PREAMBLE AT HANNAH RIDGE FILING NO. 3

CONSTRUCTION PLANS

DECEMBER 2024

SHEET 1 OF 16

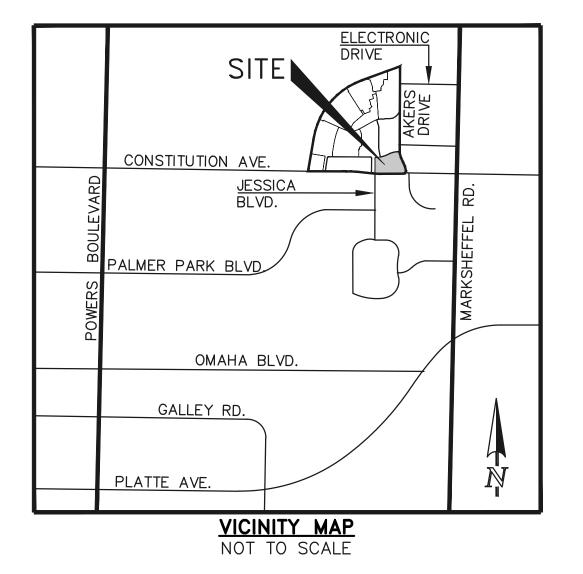
keep GEC sheets and

Plan-Profile sheets all

together in one

document.

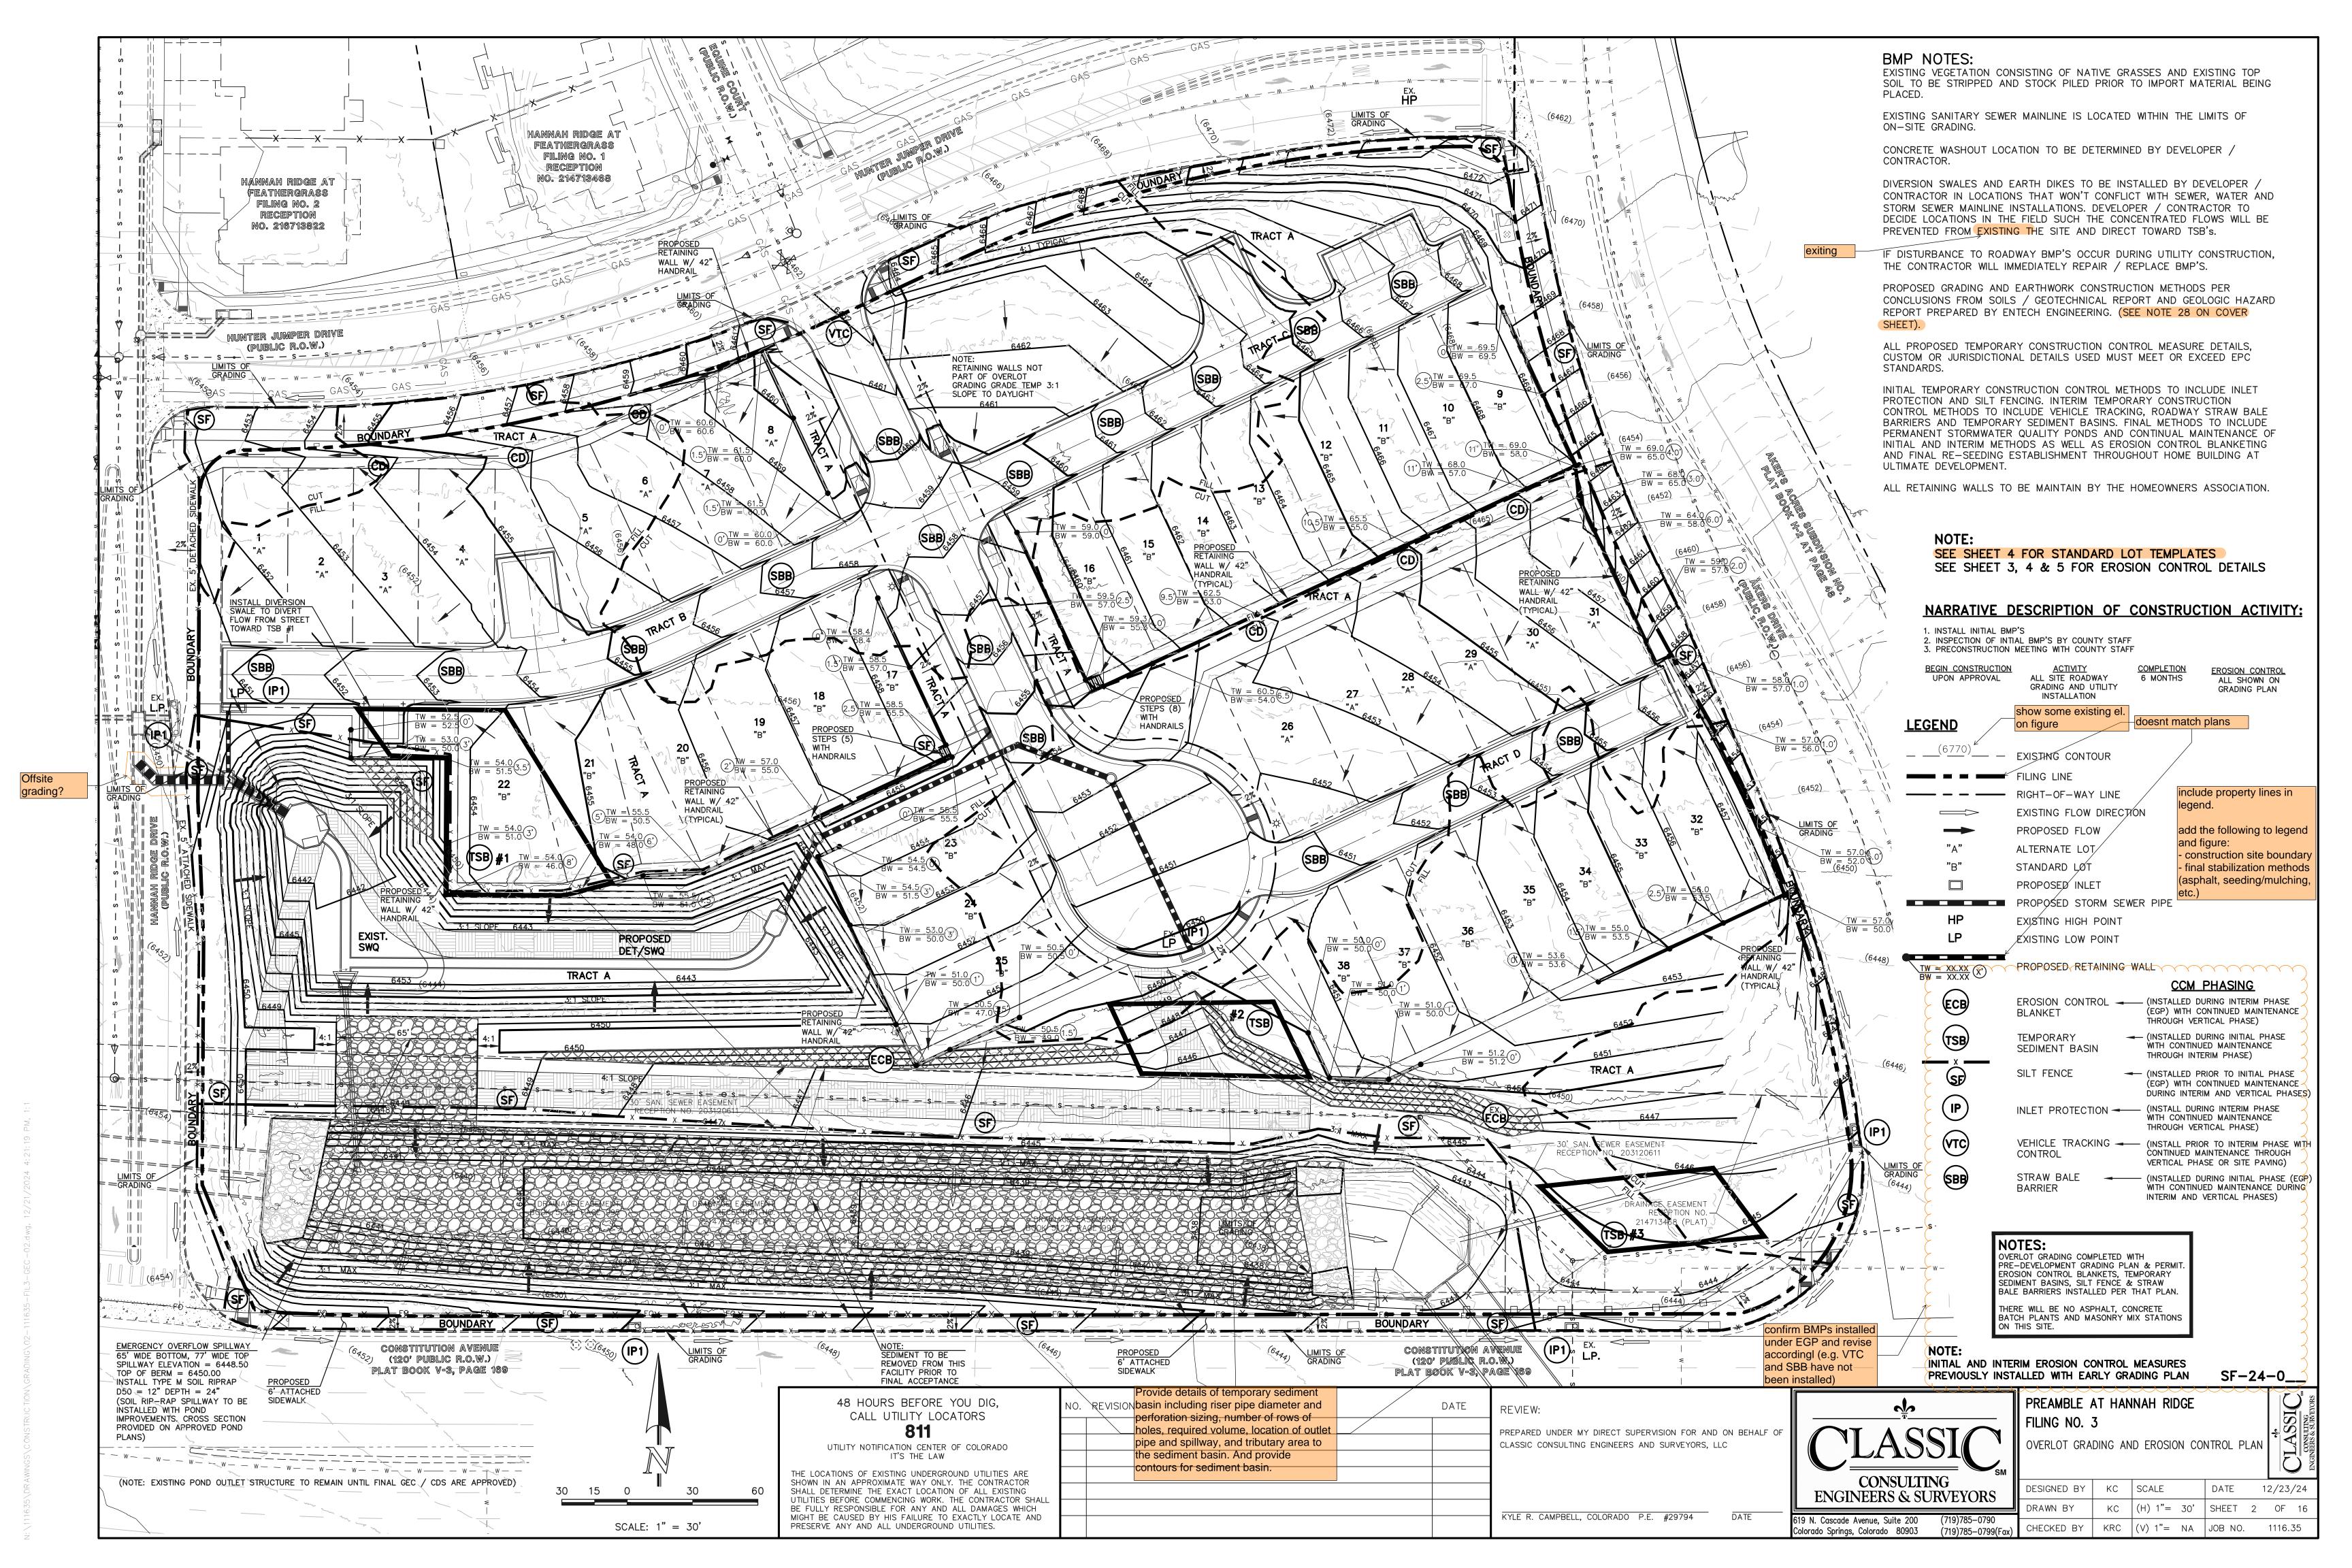
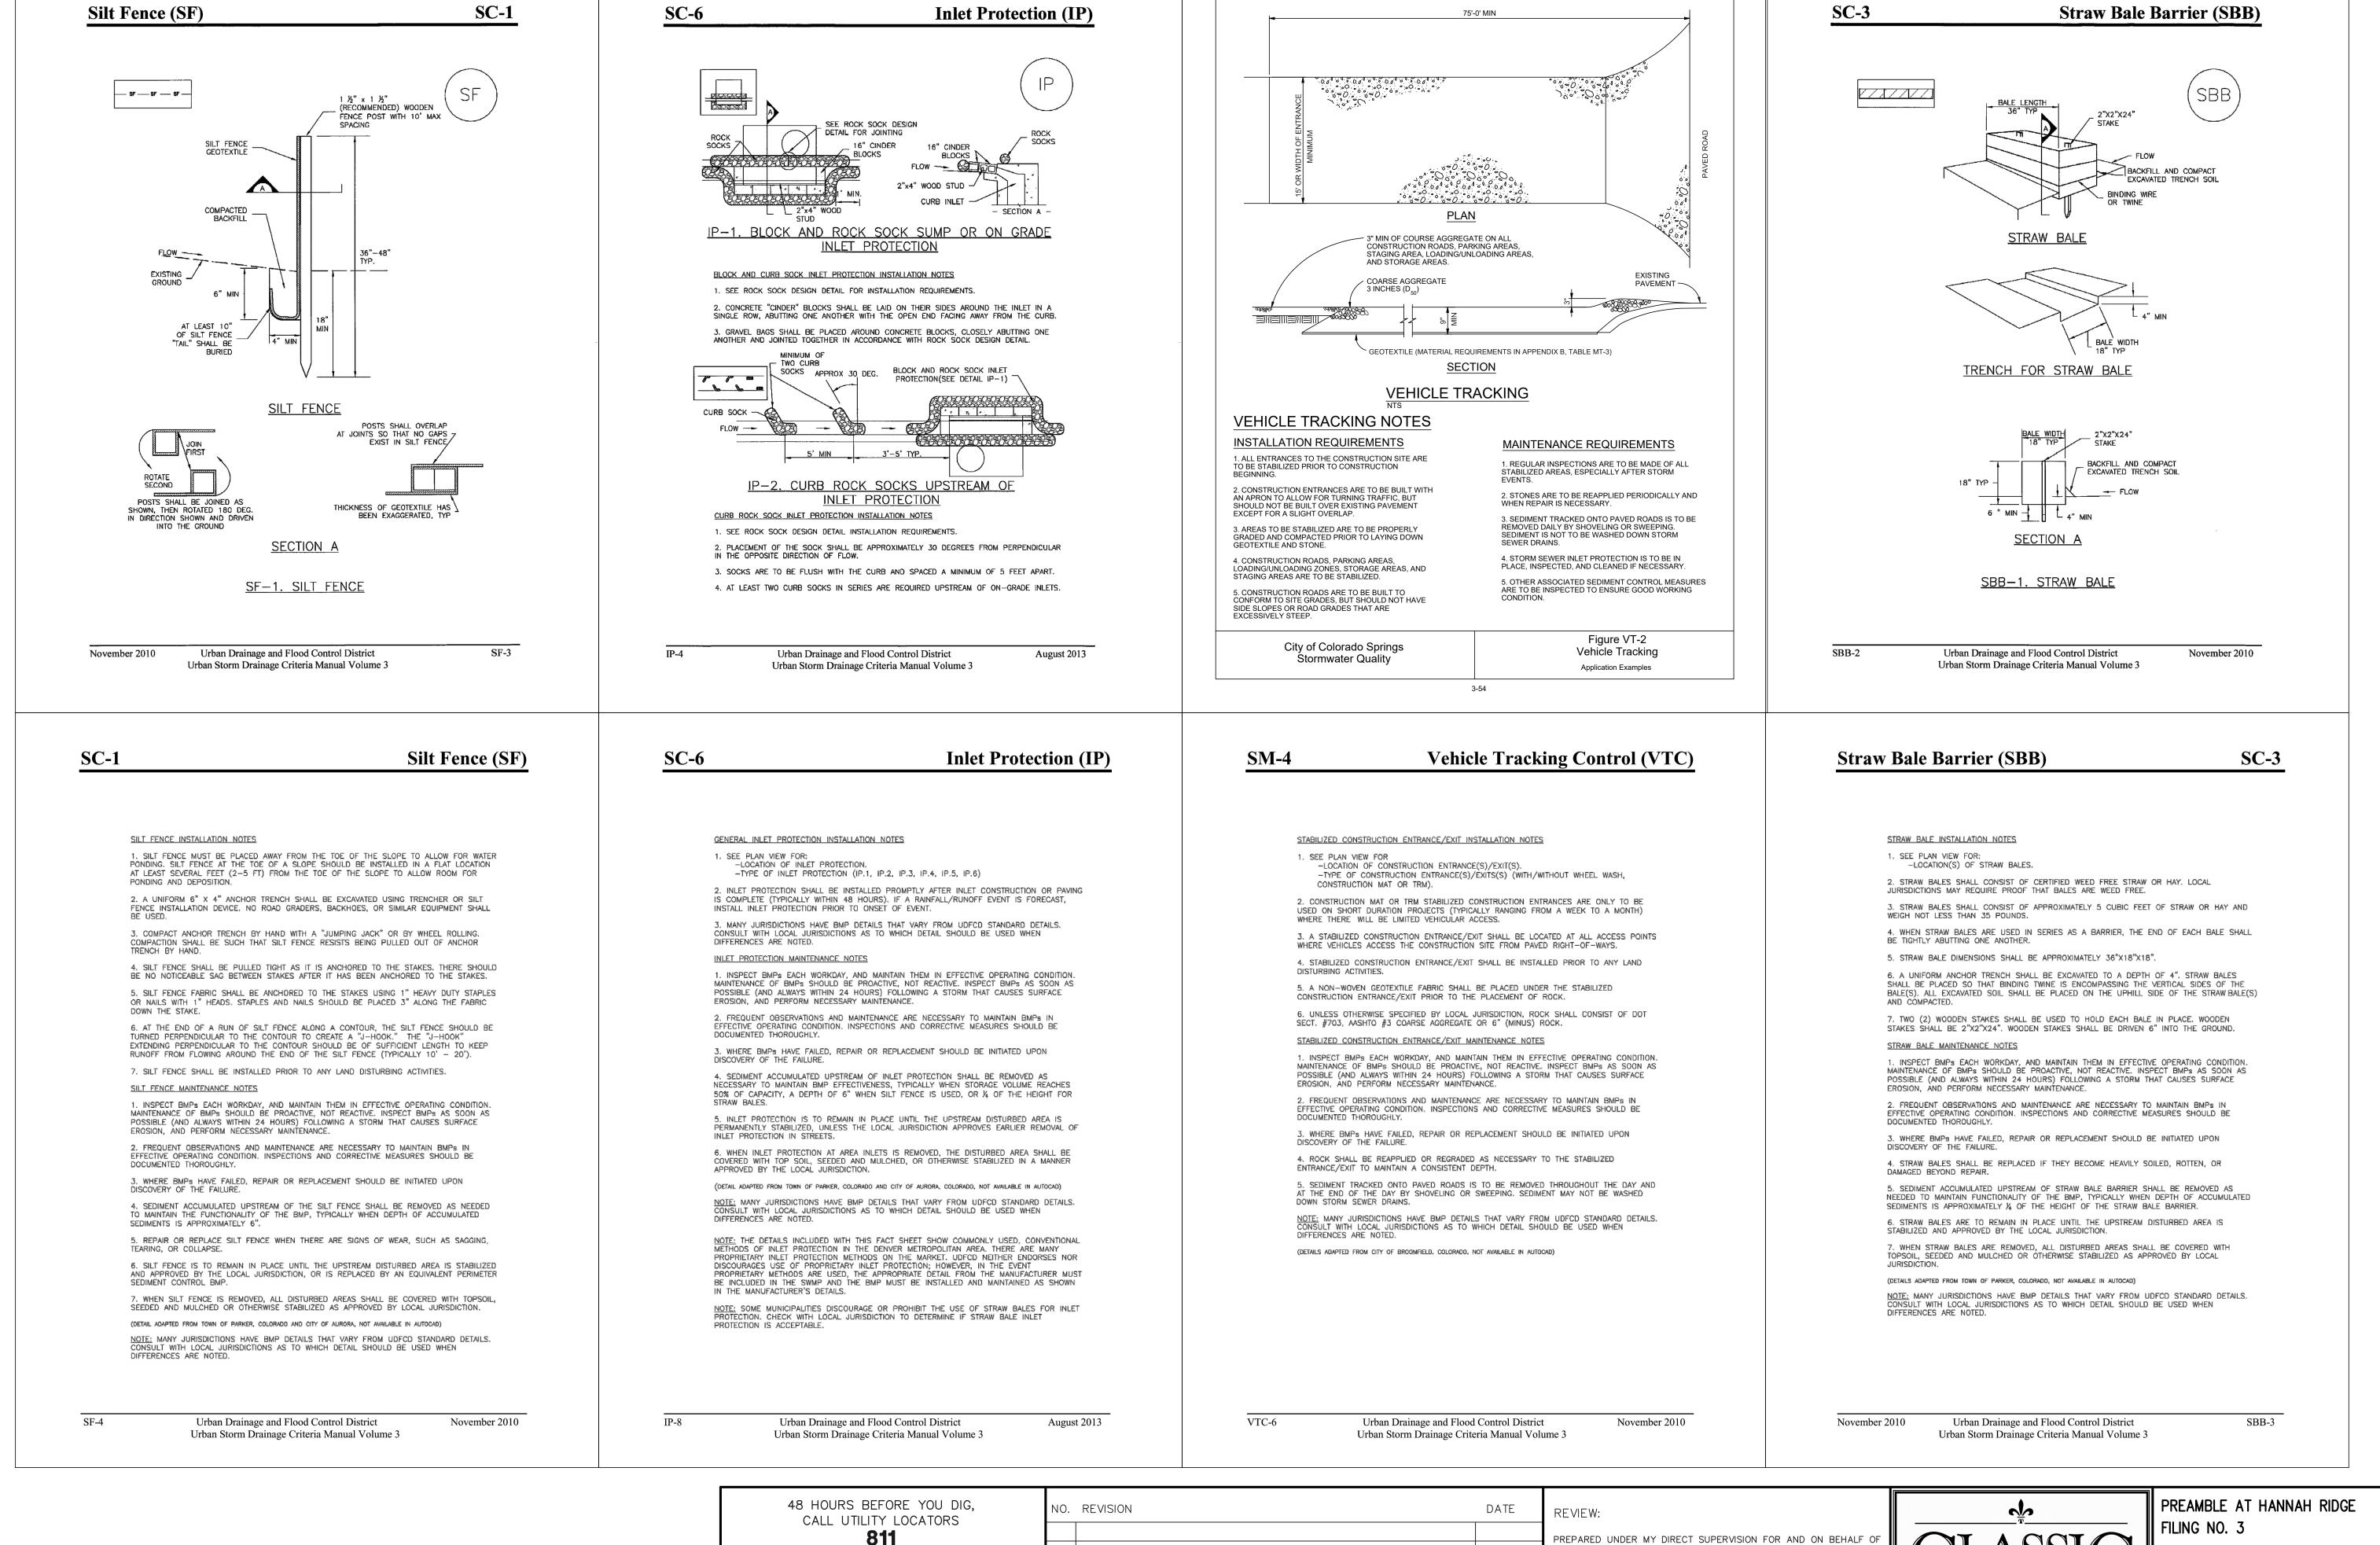
doesnt match ESQCP
